RE: DEC's Trail Construction in the Sundown Wild Forest in the Catskill Park Raises Constitutional Issues

ENB Region 3 Notices 7/14/2021, Tree Removal for the Relocation of a Section of the Long Path Trail

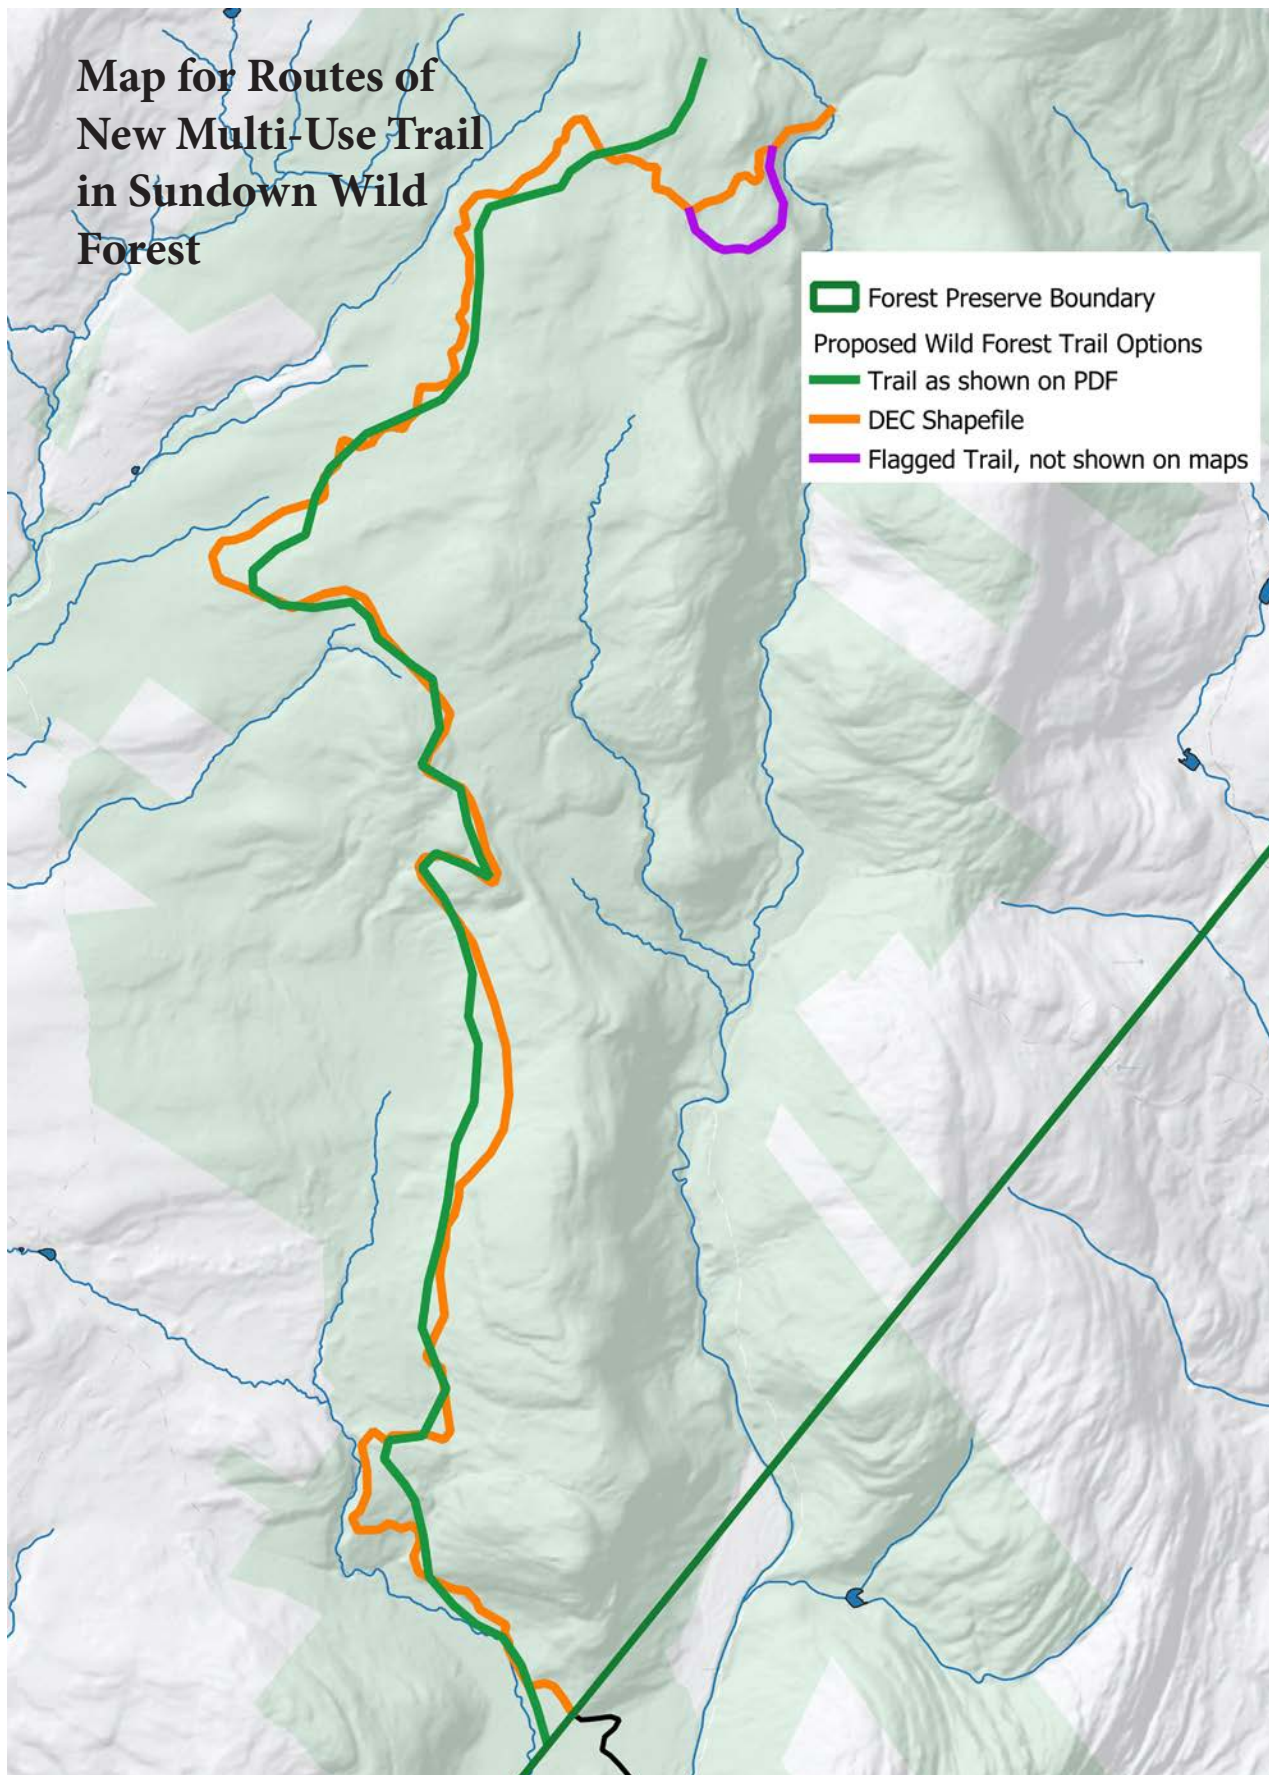
Extensive Slopes will Require Extensive Benchcuts: The proposed route for the new multi-use trail in the Sundown Wild Forest area traverses terrain with many steep slopes. We estimate that 53% of the proposed route is over grades of 10% or higher. (See the slopes map on page 6.) The proposed route traverses slopes that are 10% grade or less over 47% of the route, slopes between 10-20% grade over 30% of the route, and slopes over 20% on 23% of the route. In areas with curves or steep slopes, the DEC plans to build this trail to 8-feet in width, necessitating greater tree cutting. This trail will also require numerous long benchcuts. The extensive use of benchcuts and the flattening of the trail surface with heavy machinery will result in a trail that is in essence a Class II snowmobile trail. These trails were struck down by the courts in part due to their design. This new trail will be something very different from a foot trail. If the DEC builds this new trail in the Sundown Wild Forest like it recently constructed the multi-use trail in the Vernooey Kill State Forest, there will be many bench cut areas that are far in excess of 8 feet in width. See map on page 8 that shows areas with wide benchcuts and pictures on pages 9-16.

This map shows the slope conditions on the new proposed multi-use trail in the Sundown Wild Forest Area. The proposed route traverses slopes that are 10% grade or less over 47% of the route, slopes between 10-20% grade on over 30% of the route, and slopes over 20% on 23% of the route. DEC plans to build this trail to 8-feet in width on 53% of this trail that is on steep slopes, necessitating greater tree cutting and use of benchcuts. The steepness of the route will require frequent and long benchcuts.

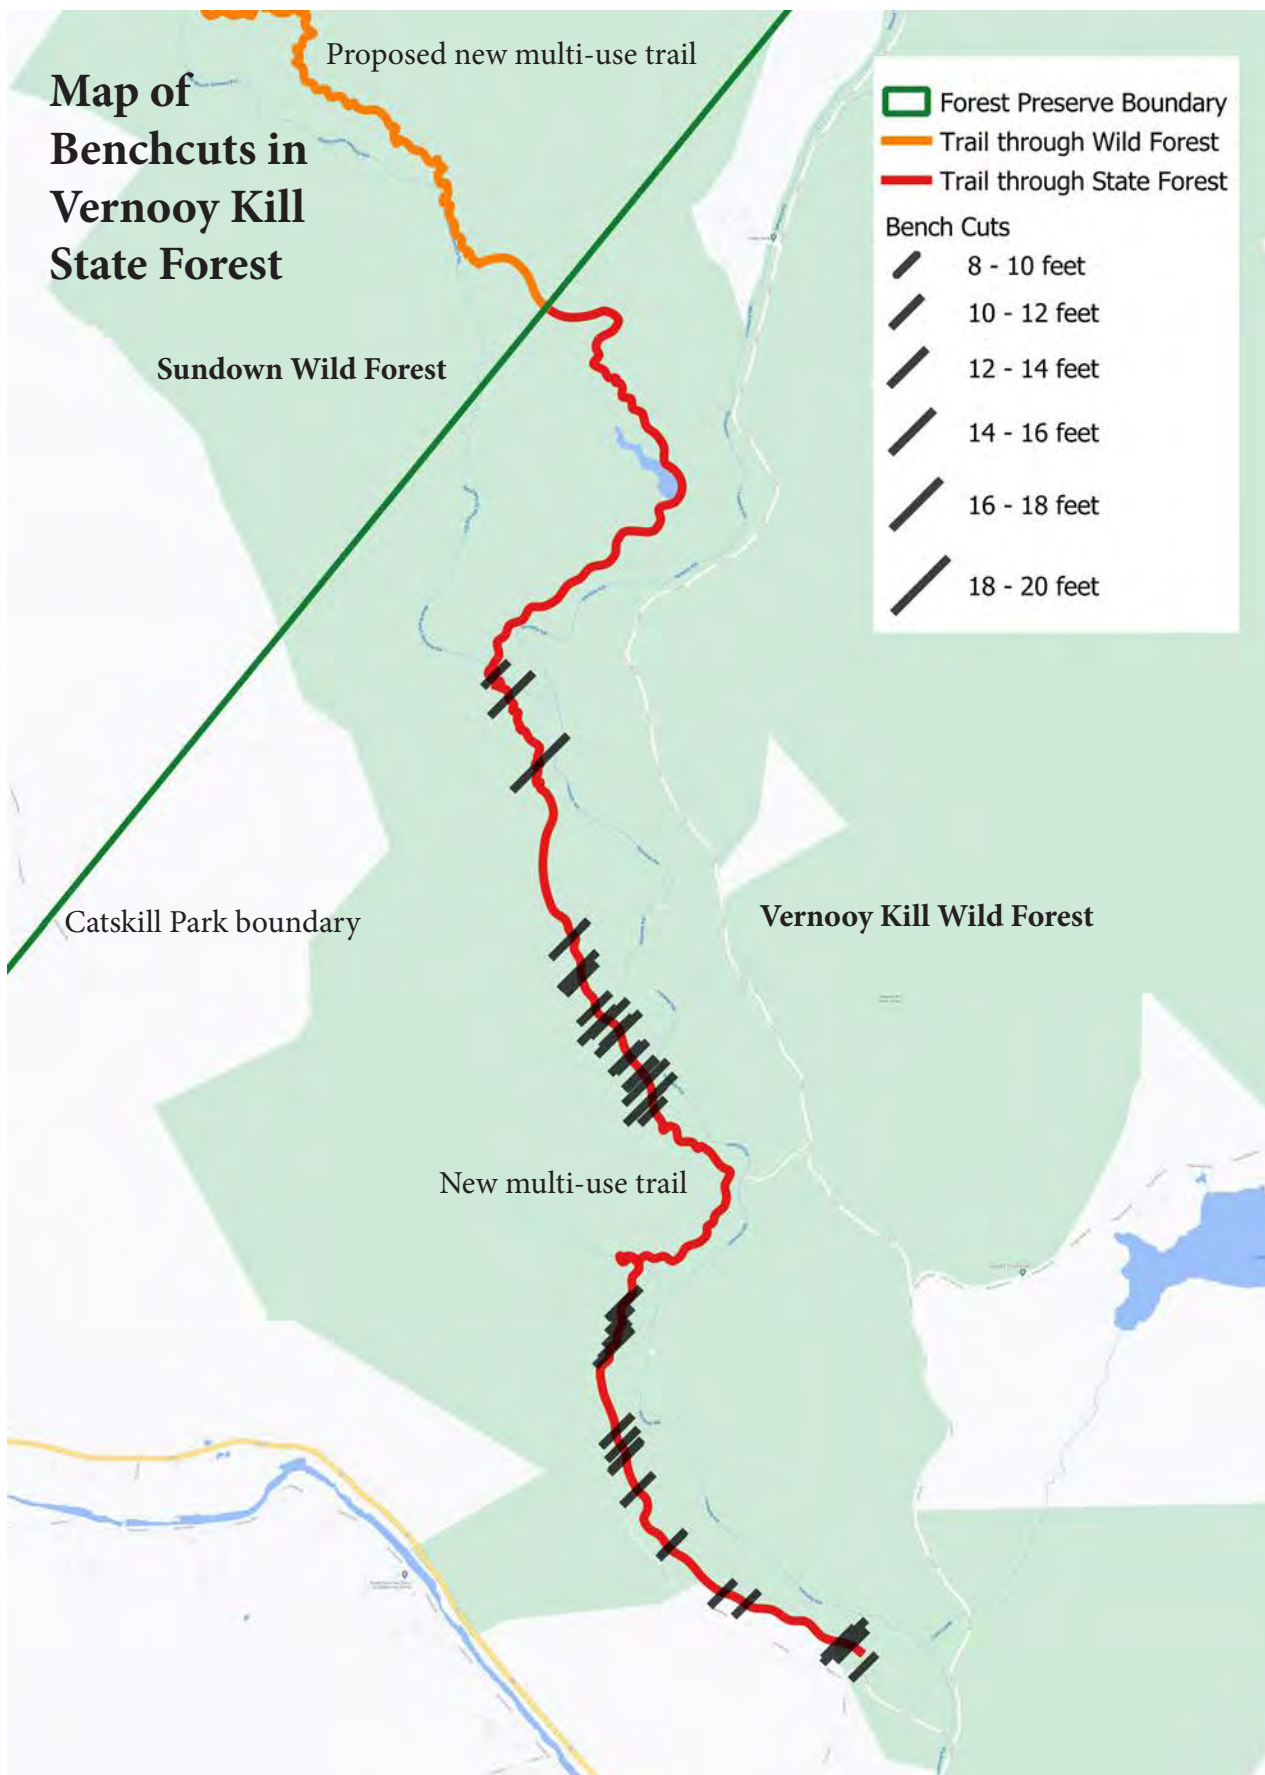
Using DEC GPS data, DEC maps, and following flags in the woods set out by DEC staff, our fieldwork found the proposed trail to be 8 miles long. It appears to us that both the ENB and Work Plan are incorrect. See map on page 7.

This map shows discrepancies in the different routes between the map in the DEC work plan, the GPS coordinates provided by the DEC, and the route that was flagged by DEC staff. This trail is 8 miles long, not 6 miles.
